Aspect Industrial Estate

Modification 2

Modifications to the Concept Plan and Stage 1 Development
State Significant Development Modification Assessment (SSD-
10448-MOD-2)

November 2022

Figure 11 | Approved (left) and the Initially Proposed (right) Deceleration Lane

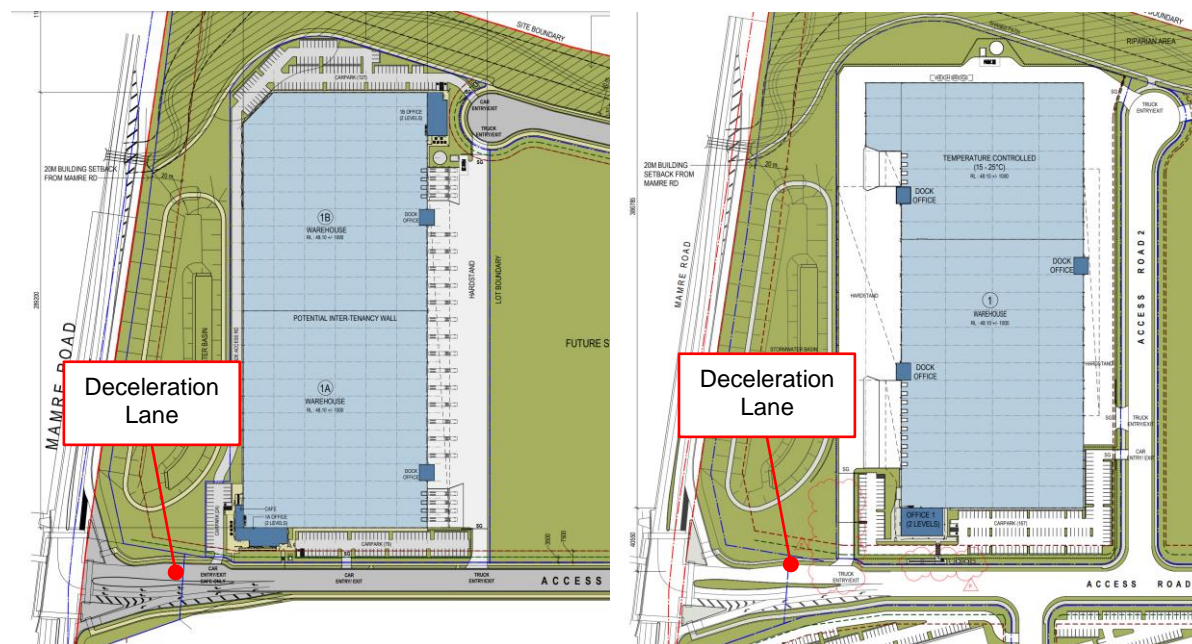
The Applicant initially proposed a deceleration lane on Access Road 1 before the proposed truck entry driveway, noting the deceleration lane was approved under SSD-10448. The only difference between the approved and the proposed deceleration lane is that the former is for a café car park, whereas the latter would be used by heavy vehicles heading to loading docks (see **Figure 11**).

TfNSW and Council reviewed the modification and did not support the amended deceleration lane on the grounds of traffic safety concerns. Specifically, given the lane is close to Mamre Road/Access Road

1 intersection (the intersection), northbound trucks on Mamre Road turning right onto Access Road 1 would need to change lanes immediately after making the right turn to use the deceleration lane. Therefore, there is a potential of causing impacts on the safe and efficient operation of the intersection.

The Applicant consulted with TfNSW on several occasions. The consultation led the Applicant removed the deceleration lane, relocated the truck inbound driveway further away from the intersection, and reconfigured the driveway (see **Figure 12**). TfNSW reviewed the further changes and considered them acceptable subject to a condition that no more than 22 trucks per hour are permitted to enter Warehouse 1.

Figure 15 | Residential Receivers outside the MRP and Place of Worship Locations

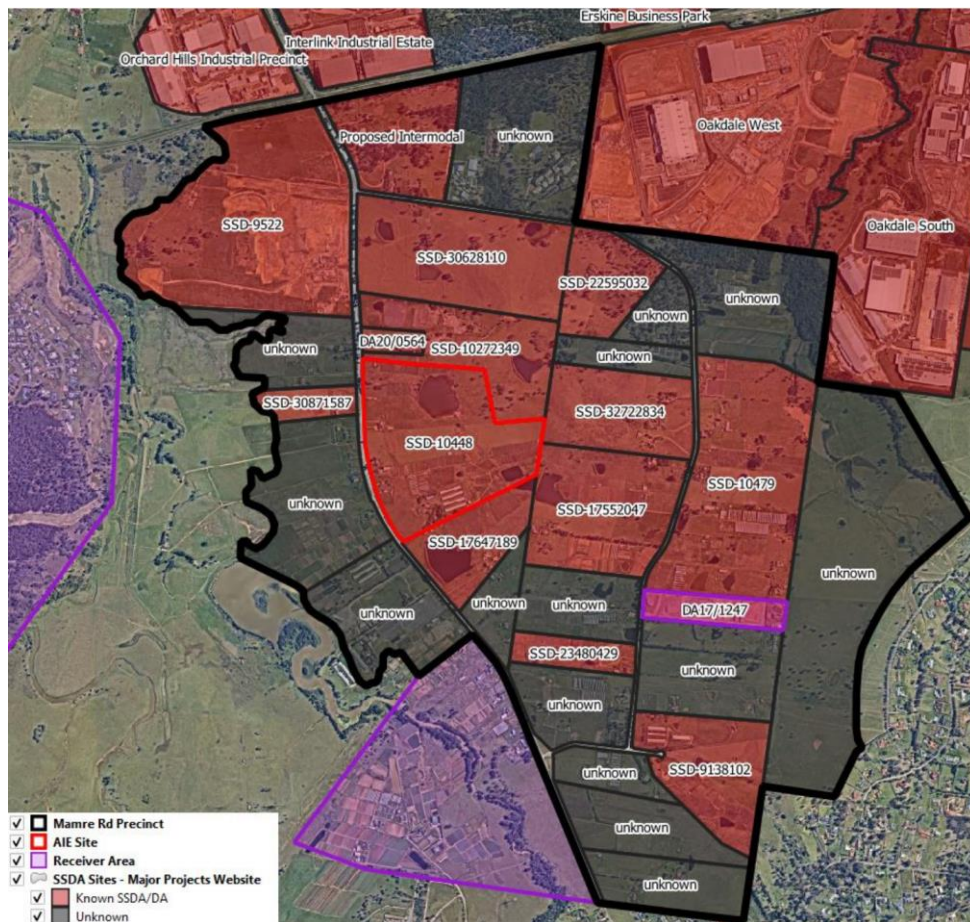
The ONIA further justified the exceedances by providing the predicted noise levels at residential receivers outside the MRP and a place of worship on Aldington Road (Penrith City Council DA17/1247) (see **Figure 15** areas outlined in purple). The ONIA established project noise trigger levels (PNTLs) utilising measured background noise levels at the receivers in 2019 and 2020 as well as the rural amenity noise levels for residential receivers to assess operational noise impacts of the modification. PNTLs and predicted noise levels at the residential receivers for the relevant day, evening and night assessment periods are presented in **Table 3**. The ONIA concluded that despite the prediction that the Stage 1 development would cause exceedances at NMLs 1 and 5, the predicted $L_{Aeq(15min)}$ at all receivers for the Concept Plan and Stage 1 development would comply with the PNTLs for all time periods considered (see **Table 3**).

The Department considers that, notwithstanding that Warehouse 1 is now proposed to be partially temperature controlled, operational noise levels were predicted to comply with the NMLs at three prescribed noise monitoring locations for both the Concept Plan and Stage 1 development. Although the NVIA predicted that Stage 1 operation would cause exceedances at NMLs 1 and 5 up to 3 dB(A), the Department considers the exceedances are caused by Warehouses 1 and 3 layout changes making NMLs 1 and 5 closer to noise sources with less shielding between the sources and the monitoring location. Further, despite exceedances at two NMLs, noise levels at sensitive receivers would comply with the relevant criteria for both the Concept Plan and Stage 1 development.
